LAW OFFICES
ARTHUR B. CUNNINGHAM
79 Checkerberry Lane, Hopkinton, NH 03229

August 7, 2025

Please consider this letter both as a follow-up to my letter to you of April 28, 2025, and Formal Comments on the proposed Eversource replacement of the X-178 high voltage transmission line that traverses over 12 miles of the White Mountain National Forest

Photograph No. 106: Looking westerly at proposed work pad location for Structure 267.

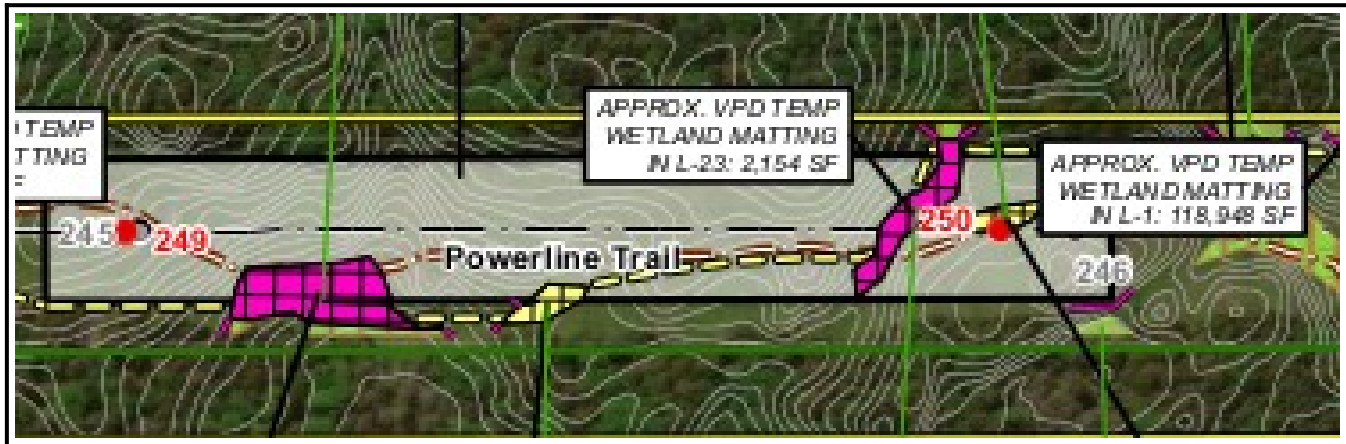
Eversource has appended a number of photographs to its application for Categorical Exclusion. See Photo Log Attachment B. Many of the photos are misleading and are not accurate representations of the site or the proposed construction work. For example, the photograph at proposed structure 267 misleads.

Structure 267 is above the Reel Brook crossing of X-178 and is situated at the top of a wet cliffy section of terrain. Eversource plans a “micro-pile” foundation here, but road construction and a 100 X 100 work pad are permitted. The site will likely require blasting, ledge hammering and conversion of the natural terrain to an industrial work area for road construction. No specifications are given for the micro-pile foundation. The structure will increase by 13’ from 52’ to 65’.

Eversource’s application for a Categorical Exclusion does not include a photograph of structure 267 from below but the 2016 PAR pole removal report does.

Photograph No. 78: Looking westerly into Wetland L-23.

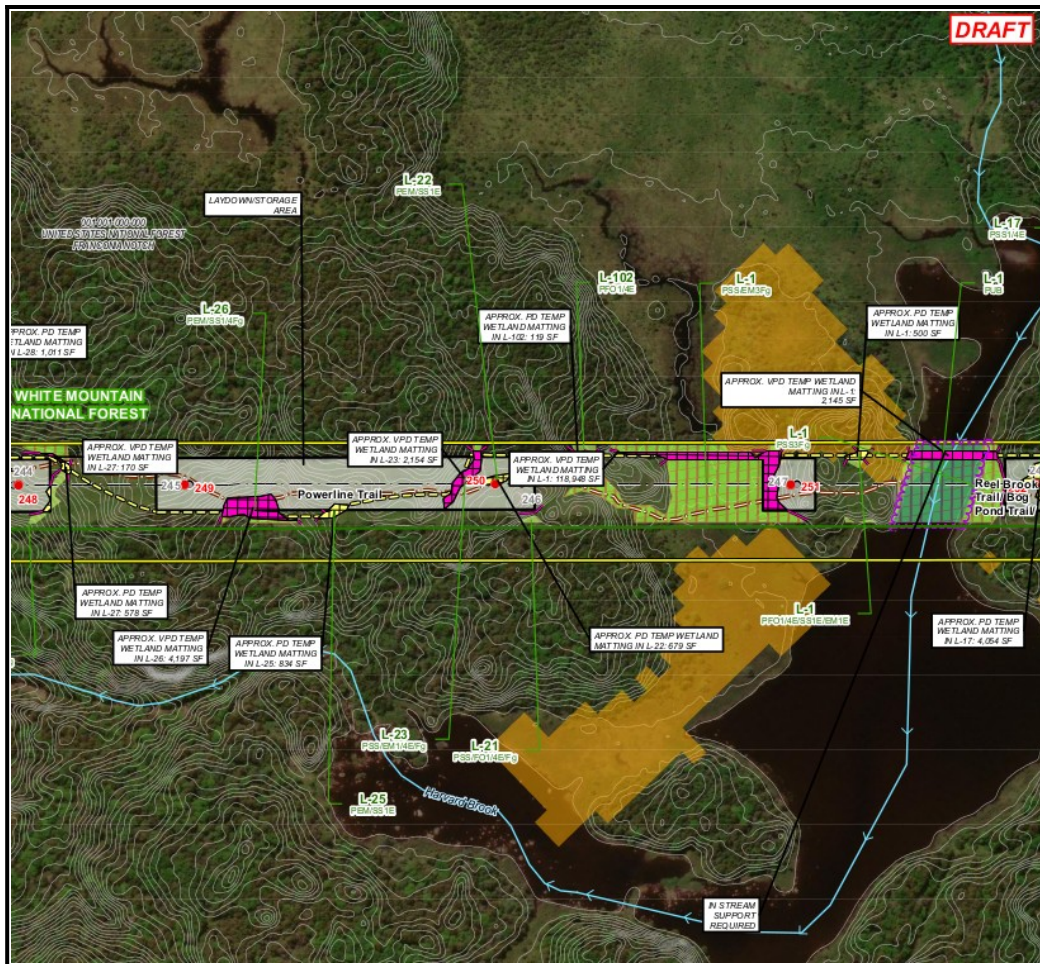
Eversource plans to construct a permanent 650' x 100' compacted gravel road/laydown/parking lot connecting two construction pads between structures 245 and 246 next to the stunning and rare high-altitude Bog Pond area. Despite the aesthetic degradation of the powerlines and structures in this Roadless Area it was barely altered on the ground by the 1948 and 1985 construction and rebuilding of the line.

The photograph below shows a view of structure 246 across Wetland L-23, shown on the plans above. This whole area would have the topsoil and all vegetation bulldozed and piled. The ledge would be destroyed and spread as fill, the area covered with riprap and gravel, and compacted. Surface and excavated

boulders would be piled at the edge of the easement. The area would look like that in the photo below of Eversource's U-199 rebuild but would be more than three times the length:

Photograph No. 102: Looking westerly at proposed access and work pad location for Structure 264.

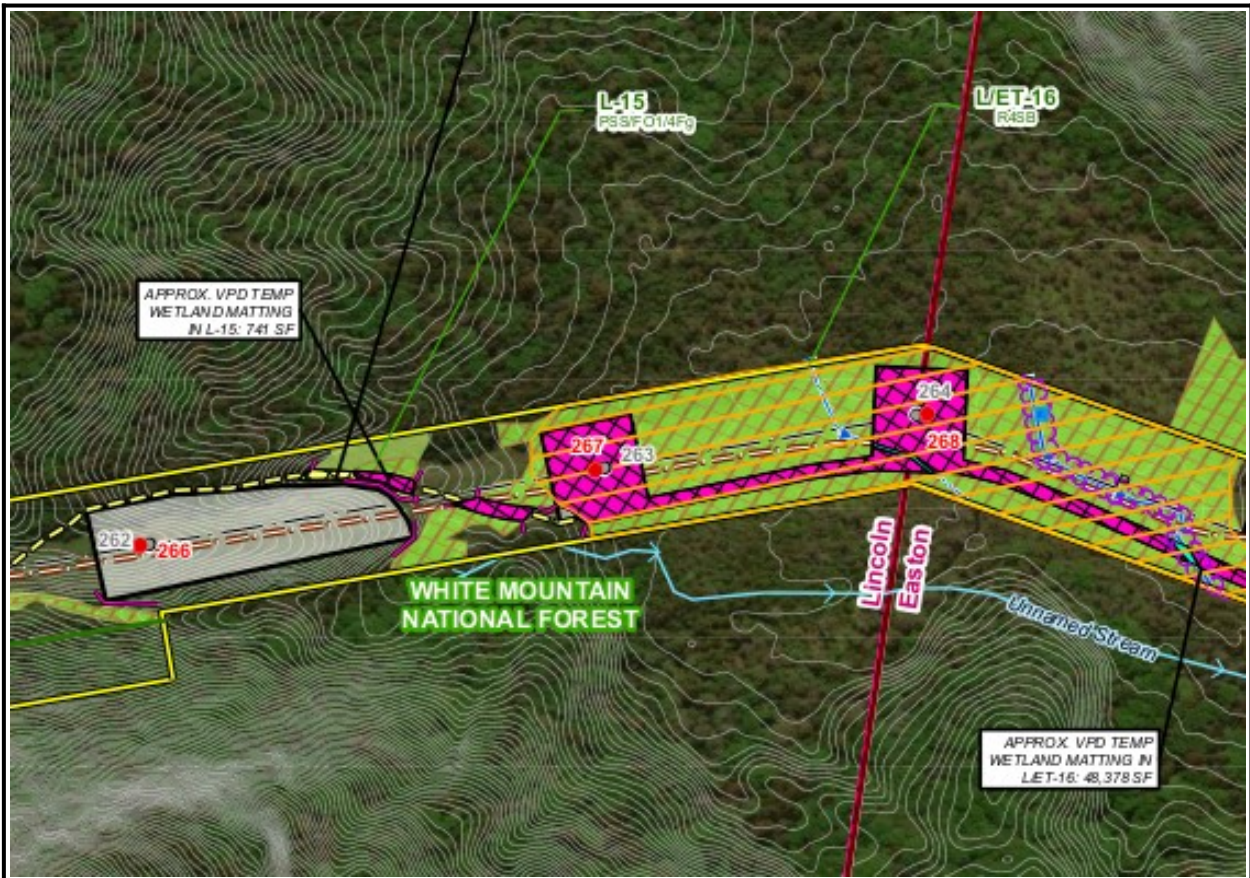
Tangent structure 264 is in small bog that Eversource and the Forest Service deemed in 2016 too environmentally sensitive to allow the removal of three wood poles dumped in there in 1985. Eversource plans geotechnical boring at the edge of the SUP area here, which could result in leaking of drilling fluids to the wetlands as occurred in at least three streams in WMNF during Northern Pass. Eversource also plans to drill either a “micro”-pile foundation or auger three 4’ diameter holes into which corrugated metal caissons would be placed to hold the metal “poles” and which would be filled with gravel. Eversource has not provided plans for how it would anchor 19 new guy wires in this bog or plans for the burial of the ground wire for the

OPGW.
Eversource plans to increase this structure height from 52’ to 61’.

Eversource plans to increase the height of the structure east of #264 from 50’ to 70’.

Photograph No. 99: Looking westerly at proposed work pad location for Structure 262.

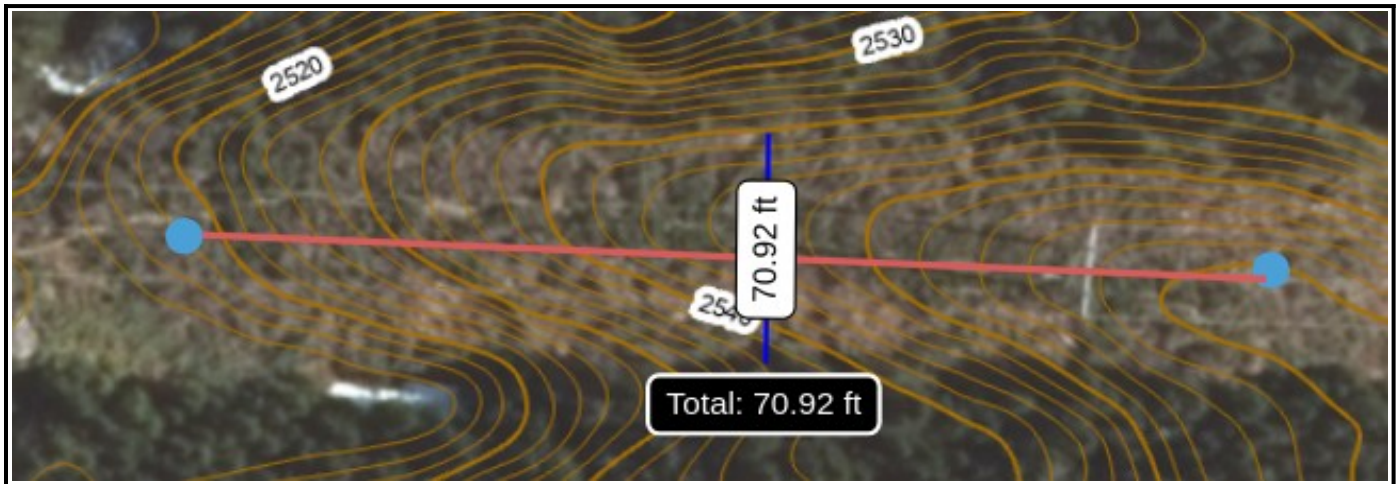
At Structure #262, Eversource plans show a 16' wide road and an approximately 325' x 100' work pad, mostly in the Special Use Permit area. Construction of this pad would obliterate a long narrow ridge that runs down the easement.

Eversource plans to level this ridge from side to side across the easement and down the steep slope of the easement. This would leave a very steep drop off at the top of its proposed leveled parking/laydown area that is not accounted for in the plans. Easton zoning requires post-construction 2' lidar contour maps. Without such maps it is not possible to visualize the drastic and dangerous slopes that would be created by this work area construction. Eversource almost certainly has 3-D modeling programs that would show its planned post-construction terrain here.

Eversource's CE application photo fails to mention the laydown area/construction pad that would cover the location from which this photo was taken as well as all the cleared terrain shown in the photo.

The project plans do not show the altitudes of the contour lines which are also obscured by the grey of the construction pad markings and completely obscured by the wetlands hatching.

Above: Eversource document. Below, AT structure 259.

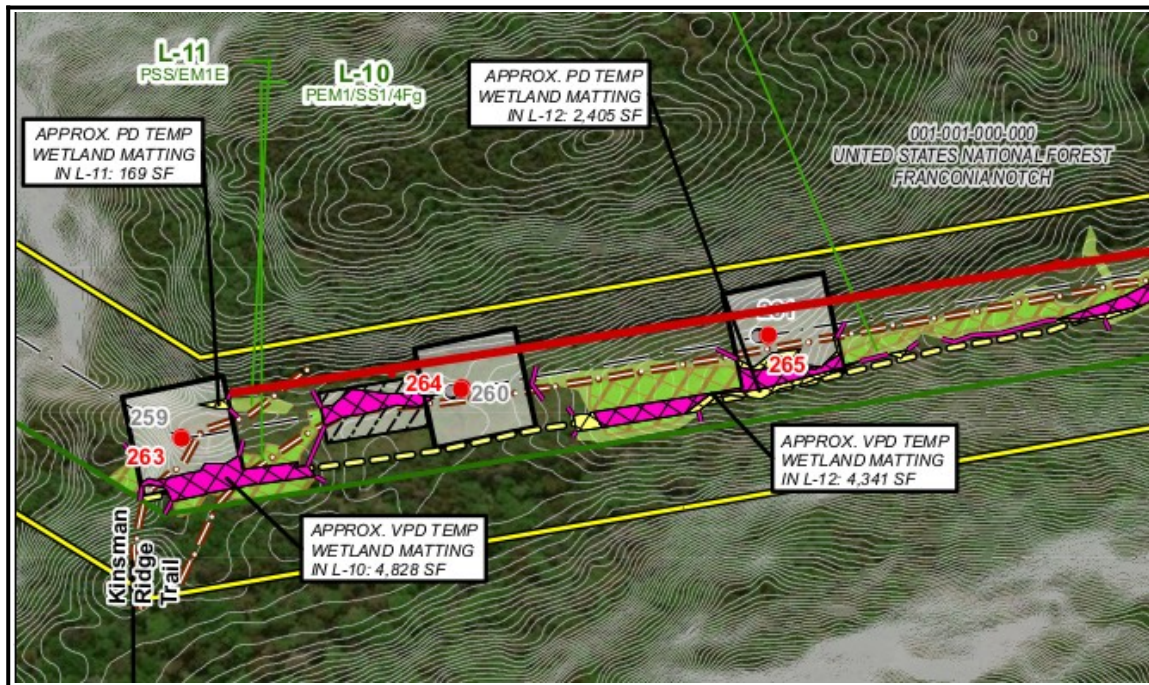
The post-construction terrain of the Appalachian Trail and surrounding area would be not be in-kind. This is shown on the project plans and noted in an Eversource email to the Forest Service 8/9/2024:

The micropile foundations planned for the AT crossing are not “in-kind” but substantially more intrusive and industrial than the existing directly embedded wood poles, as shown in a document Eversource produced for the Forest Service.
